NOTICE OF ALLOWANCE AND FEE(S) DUE

APPLICATION NO.	FILING DATE	FIRST NAMED INVENTOR	ATTORNEY DOCKET NO.	CONFIRMATION NO.
29/729,288	03/25/2020	David Buse	2599-272	7640

TITLE OF INVENTION: FLUID VIAL

FIG. 7

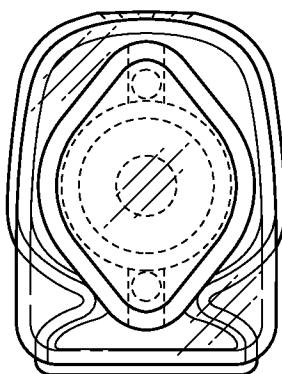
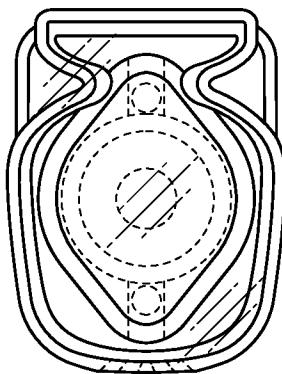
- a. The two crescent solid lines included in FIG. 1 at the top of the article adjacent to the lemon-shaped feature appear to be drafting errors.
- b. FIG. 7 is objected to for inconsistent depiction of the transparency of the top plane.

- b. FIG. 7 is objected to for inconsistent depiction of the transparency of the top plane. The topmost plane is depicted with transparency throughout the drawing set except in FIG. 7. The examiner suggests resubmitting FIG. 7 so the transparency of the article is depicted consistently throughout the drawing set. See annotated images below.

With respect to objection “b”, without quiescence or disclaimer, FIG. 7 is amended to address the objection by adding a depiction of transparency in the top plane of the container that is visible in the bottom view of FIG. 7. Accordingly, applicant respectfully requests that the objection to FIG. 7 be withdrawn.

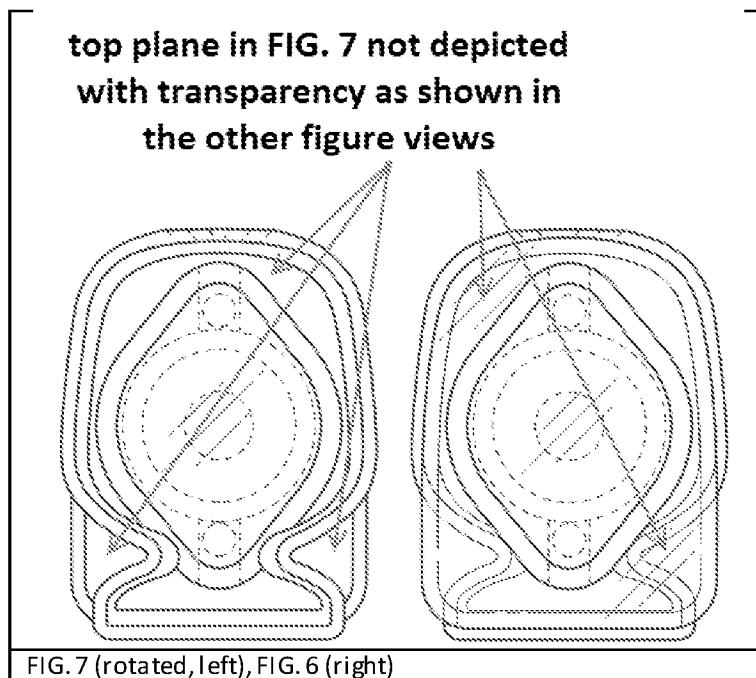
- a. **The two crescent solid lines included in FIG. 1 at the top of the article adjacent to the lemon-shaped feature appear to be drafting errors.** The lines described which are now seen as solid in FIG. 1 seem to be drafting errors, as the other figure views do not show corresponding features in solid lines. The examiner suggests resubmitting FIG. 1 so these lines are in broken lines as originally disclosed. See annotated drawing on the following page.

With respect to objection "a", a copy of the annotated version of FIG. 1 from the Quayle action is reproduced below with applicant's further annotations added. The apparent drafting errors identified in the Quayle action are, in fact, the mirror image portions of the lines labeled "A" and "B" below on the right side of the container and which are partially visible on the left side of the container in the orientation of FIG. 1.

FIG. 1 of Original Disclosure (left), FIG. 1 of Replacement Drawing Set - 23 August 2022 (right)

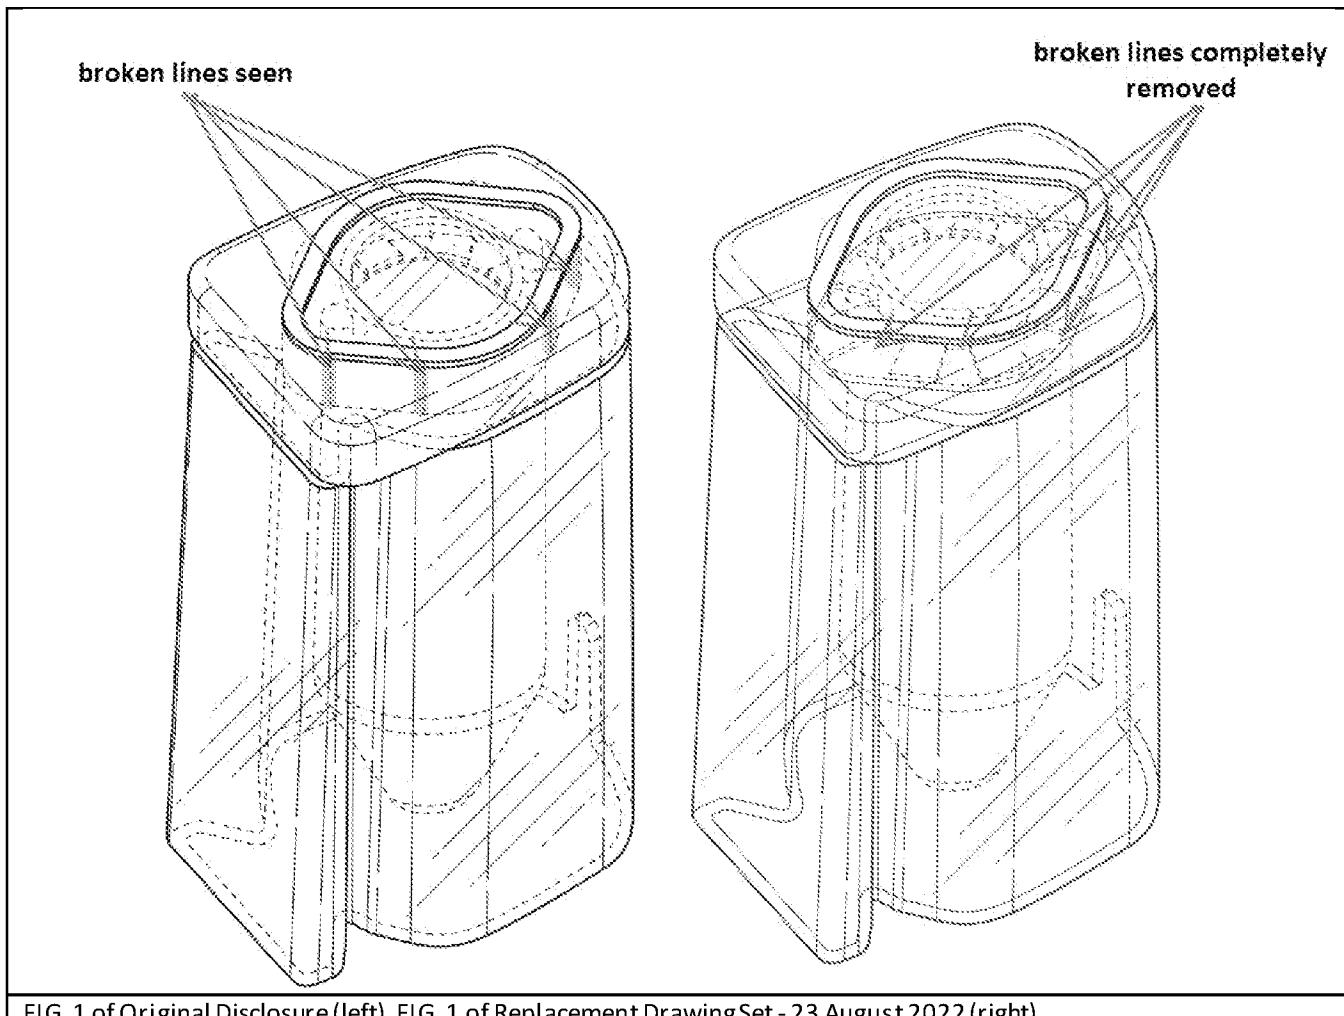
Applicant is advised that there is no support in the original disclosure to allow one skilled in the art to understand the addition of features in broken lines at the top center of the fluid vial throughout the drawing set, the removal of lines broken and solid from the sides of the lemon-shaped feature in FIGs. 1 - 5, nor the change of certain claimed features in FIG. 6 and 7 from flat to curved.

To show the sides of the lemon-shaped feature as transparent, applicant has added internal features of the fluid vial to its top center in broken line. Applicant states support for these features can be found in the original application in "...FIG. 1, ...FIG. 8, and ...FIG. 13." However, as applicant has elected Embodiment 1 (FIGs. 1-7) without traverse in the election received 24 February 2022, only the features that are present in FIG. 1 have basis in the original application. There is no basis in the original disclosure to now include additional information present within the top center portion of the fluid vial in **all figures 1 -7**. See annotated drawings exemplifying this issue below.

Applicant's response states broken lines seen on the sides of the lemon-shaped feature have been removed "[b]ecause these lines do not 'aid[] in understanding the invention'...." Applicant states these lines are contour lines; however, throughout the drawing set in all of its iterations, they have been presented in contradictory presentations of solid and broken lines, but *not* contour lines. For this reason, their removal is considered new matter. There is no basis in the original disclosure to now remove these lines from the sides of the lemon-shaped feature **in FIGs. 1 - 5**. See annotated drawings exemplifying this issue on the next following pages.

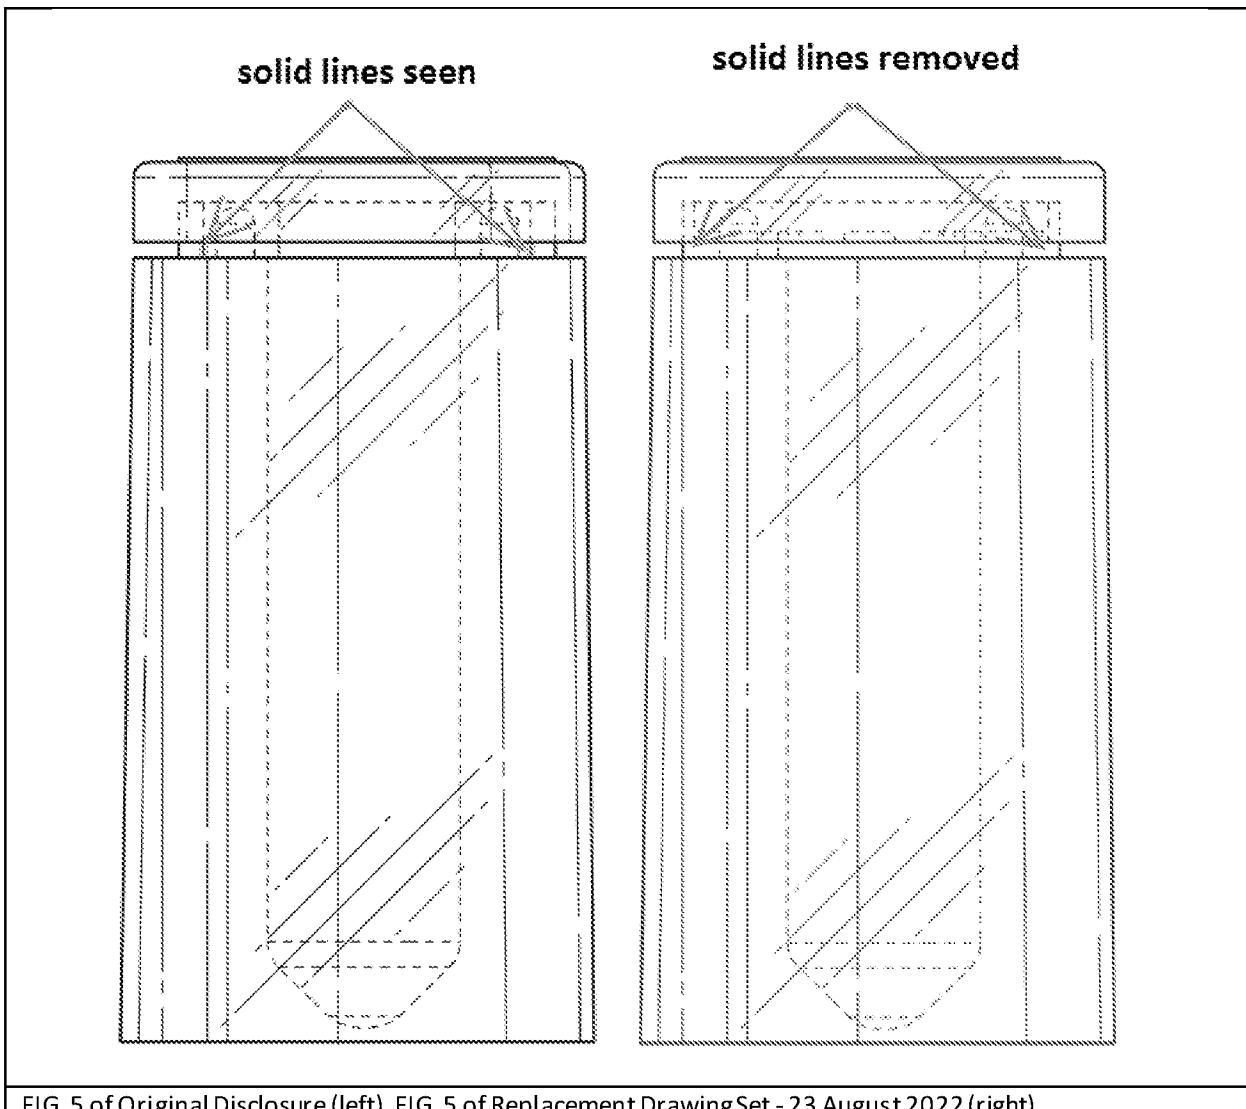
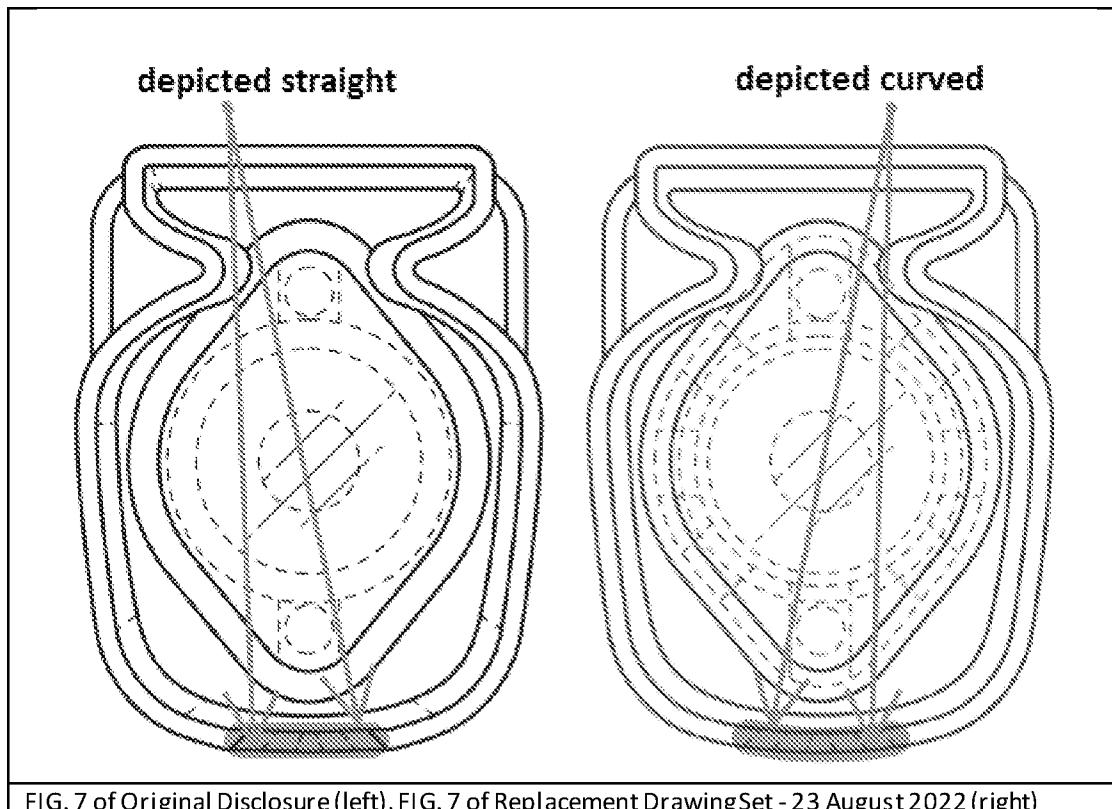
Applicant has inexplicably changed the solid lines above and below the curved feature depicted in broken lines on the back of the article from straight to curved in top and bottom **views FIG. 6 and 7**. There is no basis in the original disclosure for this change. See annotated drawings exemplifying this issue below.

Circled contour lines removed

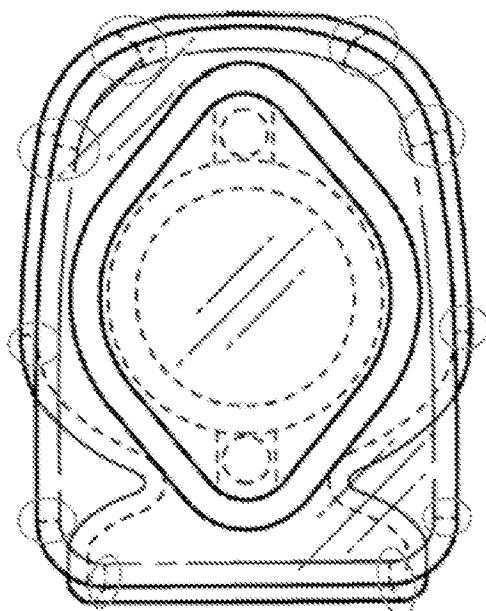
The particular objections are set forth in the following annotated drawings set forth at page 3 of OA2:

As explained during the Examiner Interview, since the contour lines around the inner and outer perimeter of the container are so short in FIG. 6 (the top view) and FIG. 7 (the bottom) view, it is not feasible to present them in a way that does not look like a broken line. As noted in the Office Action, “the use of contour lines in views is encouraged if it aids in understanding the invention and if it does not reduce legibility.” OA2 at p. 2. In this case, Applicant believes the short contour lines in FIGS. 6 and 7 do not aid in understanding the invention and do reduce legibility of the drawing – as evidenced by the objection to the contour lines. Accordingly, FIGS. 6 and 7 are amended to remove the short contour lines.

FIG. 6

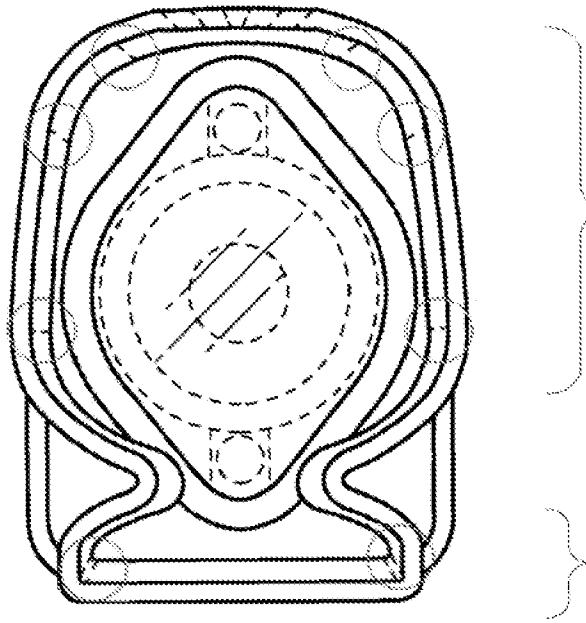
2. “The tip of the inverted pencil-shaped feature is depicted inconsistently, as the bottom circular broken line seen throughout the figure views is not seen in the top view of FIG. 6.” OA2 at p. 5.

3. “The bottom plane, including the arched feature seen on the front of the article, is not seen in the top view.” OA2 at p. 5.

FIG. 6 (top view) and FIG. 7 (bottom view) are revised to show the bottom circular broken line in both views and to show the annular feature on the top surface of the lid and so as to be consistent with all other figures/views.

FIG. 6 (top view) is revised to show the bottom plane, including the arched feature seen on the front of the article.

FIG. 1

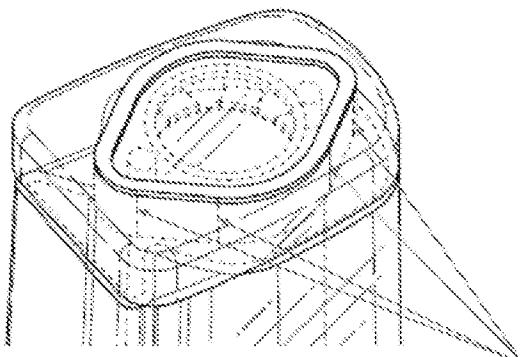
The lines on the sides of the “lemon-shaped feature” referred to in the Office Action are contour lines. Because these lines do not “aid[] in understanding the

invention” – as is evidenced by the rejection, these lines are removed from the drawings, as shown in the drawings below.

FIG. 1 is revised to show the sides of the “lemon-shaped feature” as transparent, with features of the Fluid Vial internal to the sides of the lemon-shaped feature shown in

FIG. 7 (rotated, top left), FIG. 6 (top right), FIG. 1 (bottom left), FIG. 5 (bottom right)

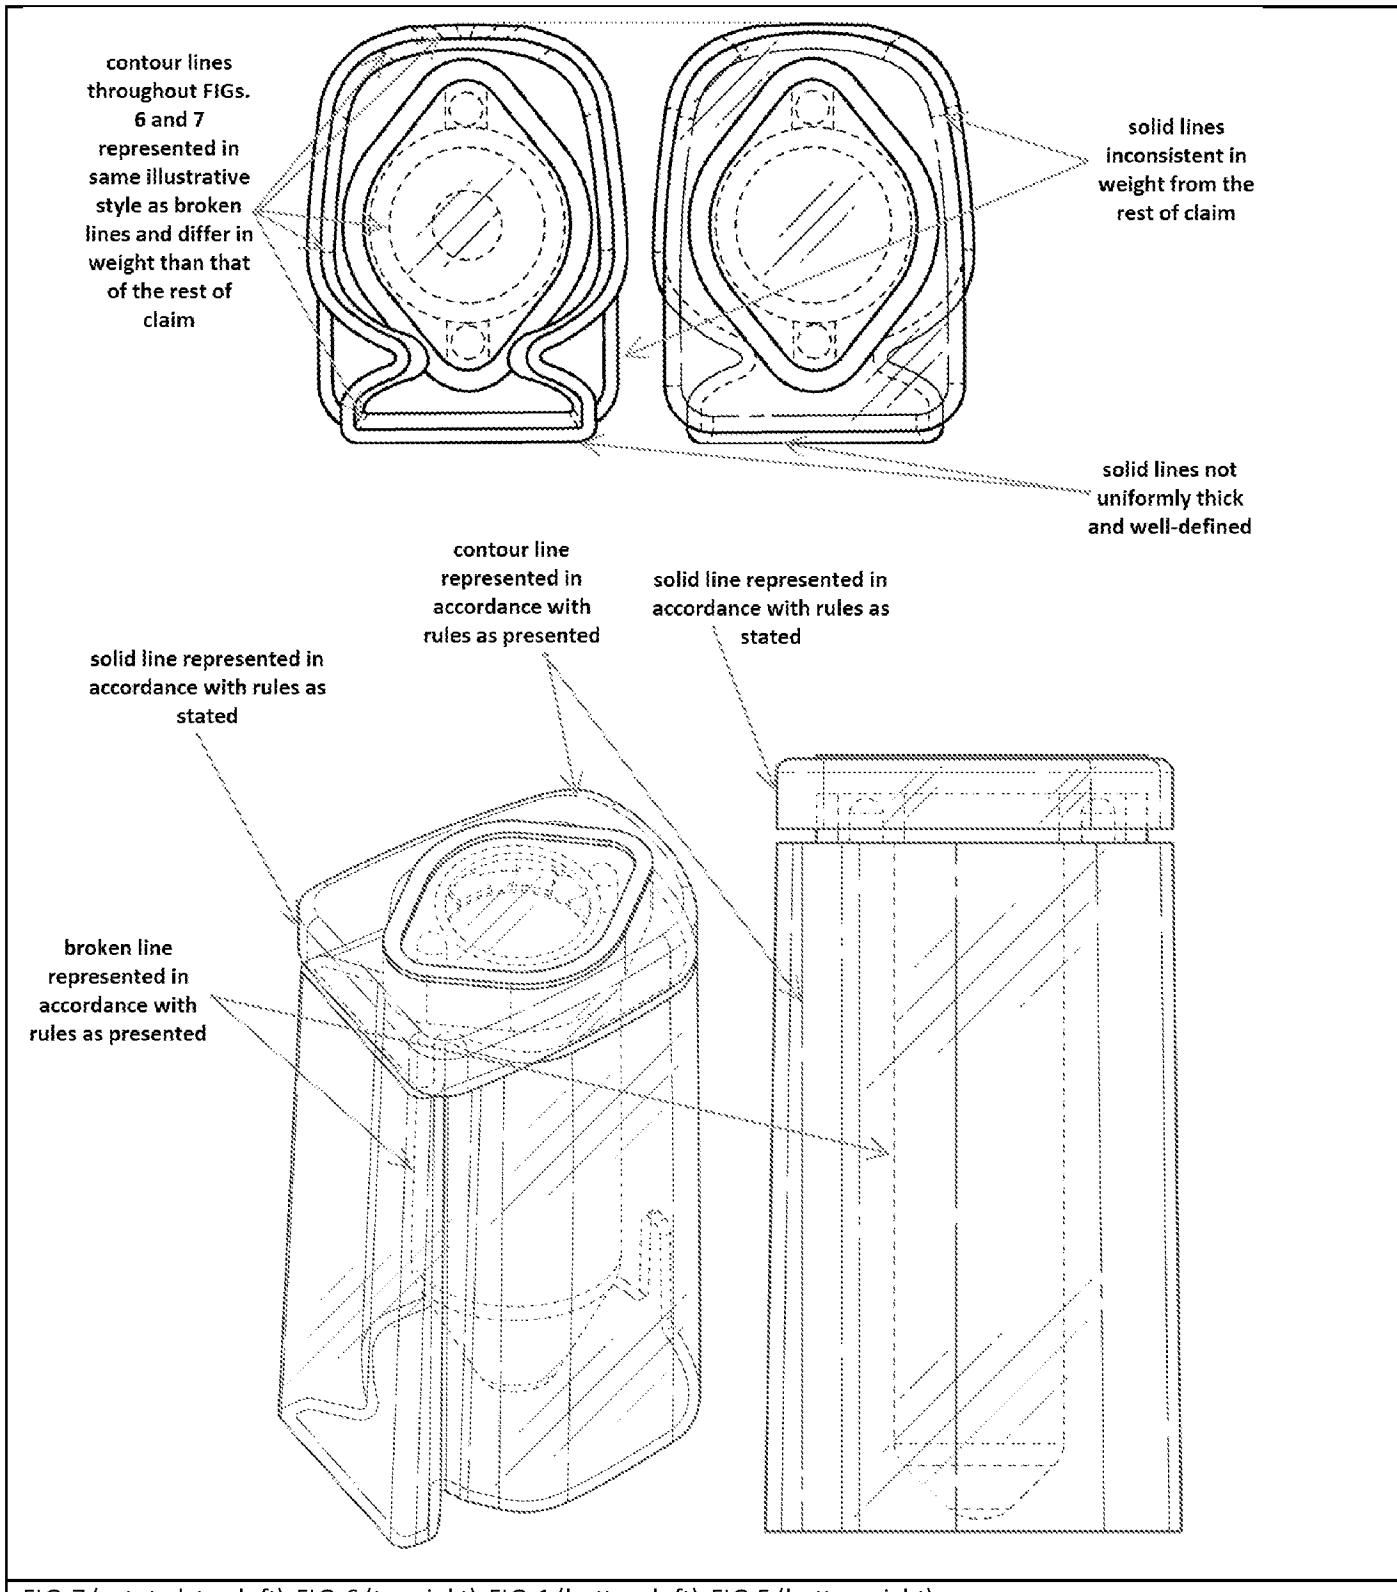
must be clearly represented and must be consistent in depiction throughout the drawing set.

FIG. 7 (rotated, left), FIG. 6 (middle), FIG. 1 (right)

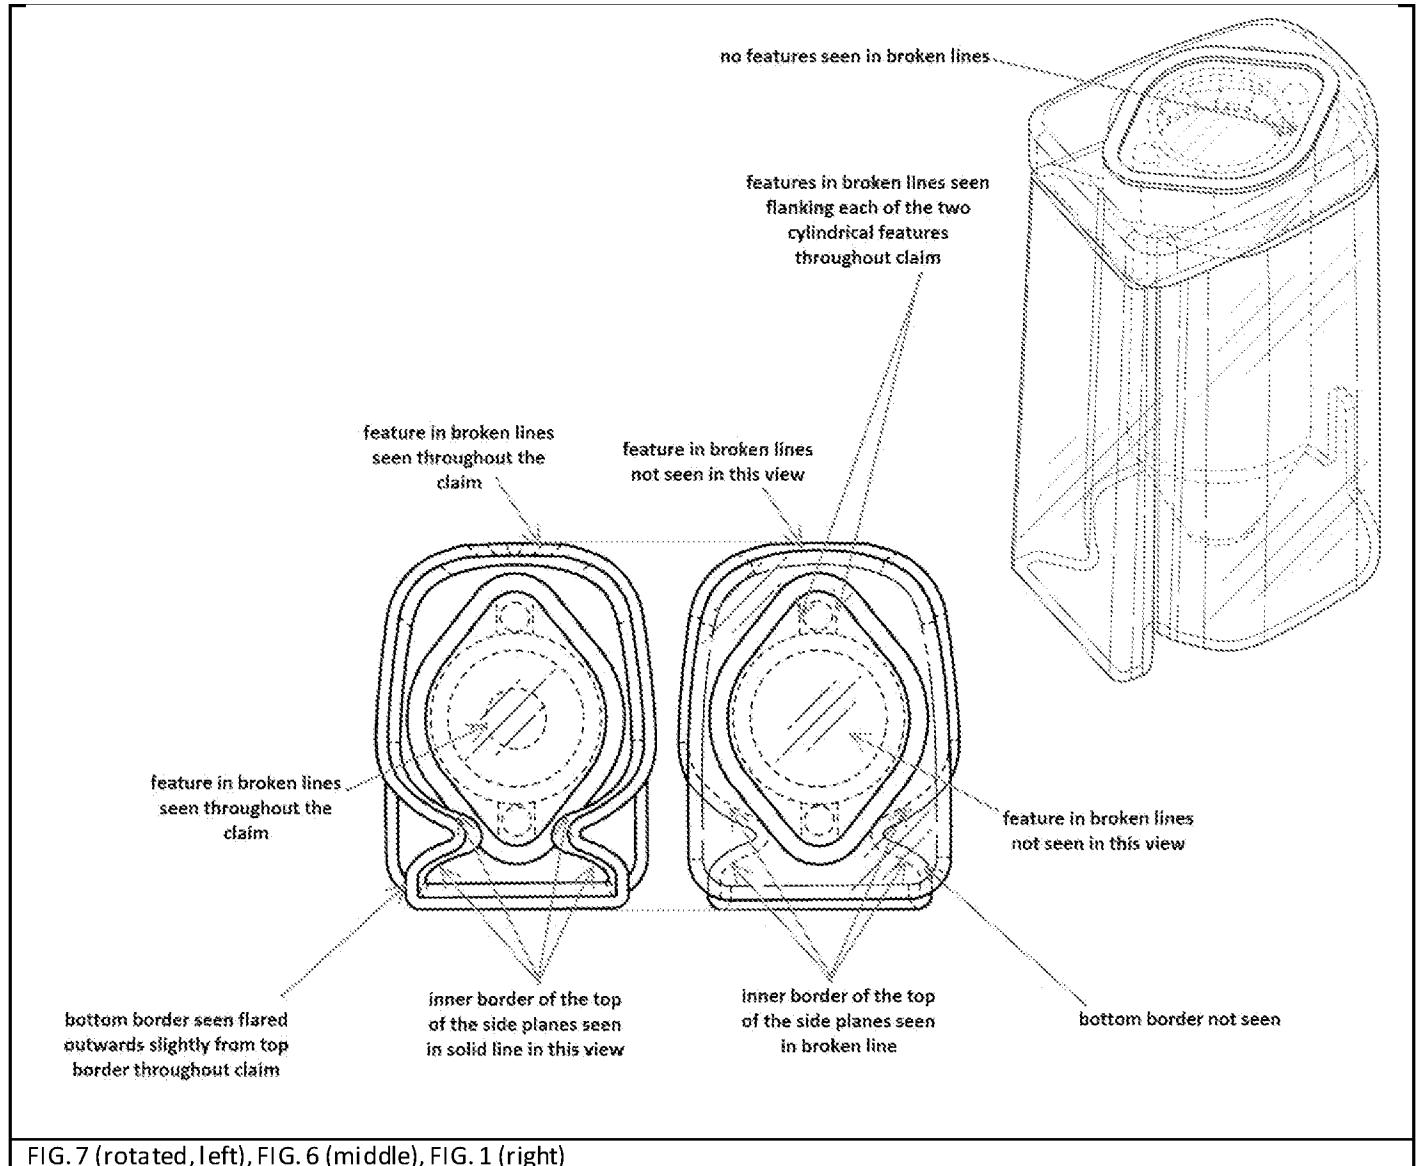
1. There are inconsistencies between the views of the drawings and the overall appearance of the design is unclear (MPEP § 1504.04), specifically:
 - a. **There are features depicted inconsistently throughout the claim.** There are certain features seen in some views while other views do not show these features. Specifically, there are two broken lines which flank the two circular features in the top and bottom

views which are not seen in the perspective view. The tip of the inverted pencil-shaped feature is depicted inconsistently, as the bottom circular broken line seen throughout the figure views is not seen in the top view of FIG. 6. The bottom plane, including the arched feature seen on the front of the article, is not seen in the top view. The exact configuration of the claimed features indicated is unknown and therefore the claimed design is indefinite. See annotated drawings on next page.
